Re: 1000 West Bruce Street - MKE -BRRTS # 02-41-523114
Post Closure Modification Notification

EXHIBIT 1

FORMER BLACKHAWK TANNERY
 MILWAUKEE, WISCONSIN

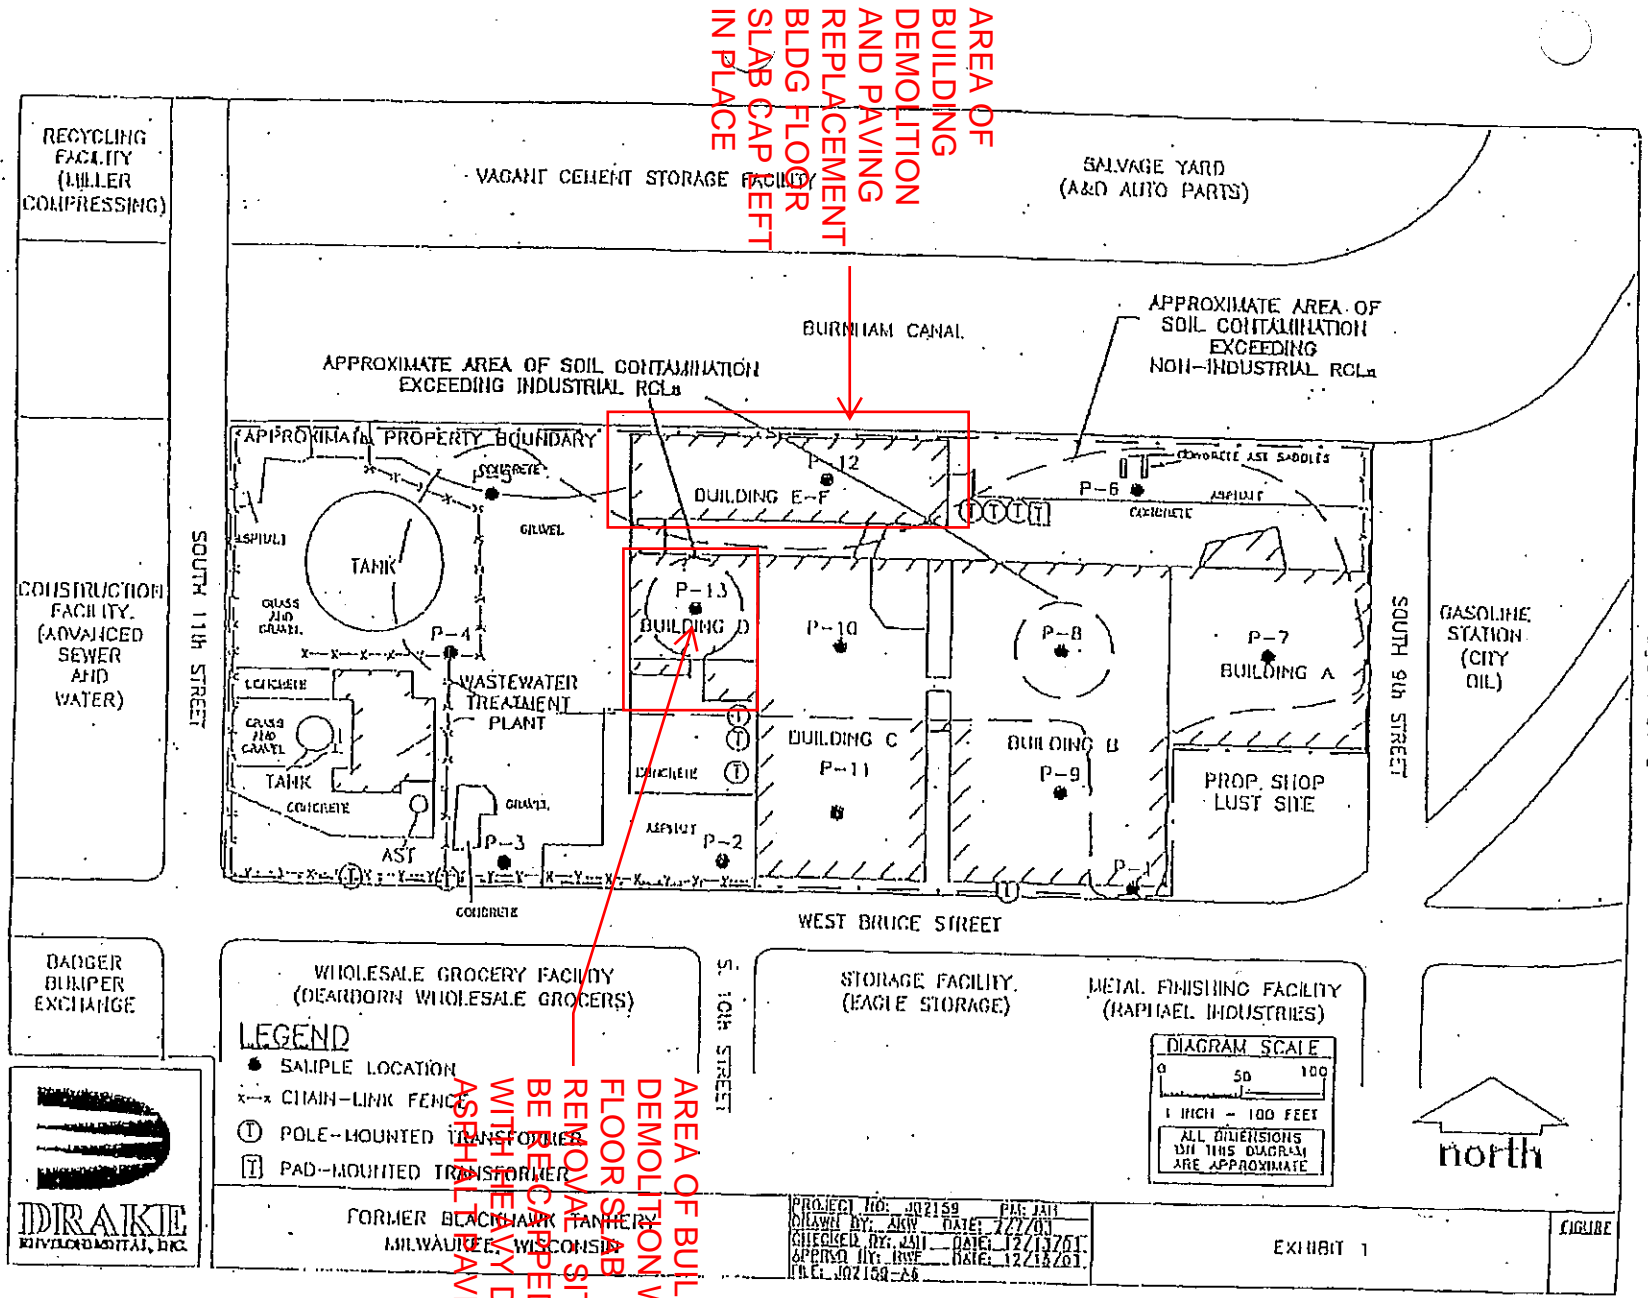
The building demolition areas were to have the existing floor slabs remain in place and repave over the top of the slabs. These were damaged and subsequently broken up or removed during demolition. The existing soils, potentially contaminated, have and will remain in place and be re-compacted, covered with a compacted granular base course and paved with a 4" asphalt paving course.

AREA OF BUILDING DEMOLITION AND PAVING REPLACEMENT BLDG FLOOR SLAB CAP LEFT IN PLACE

AREA OF BUILDING DEMOLITION WITH FLOOR SLAB REMOVAL SITE TO BE RECEPTED WITH HEAVY DUTY ASPHALT PAVING
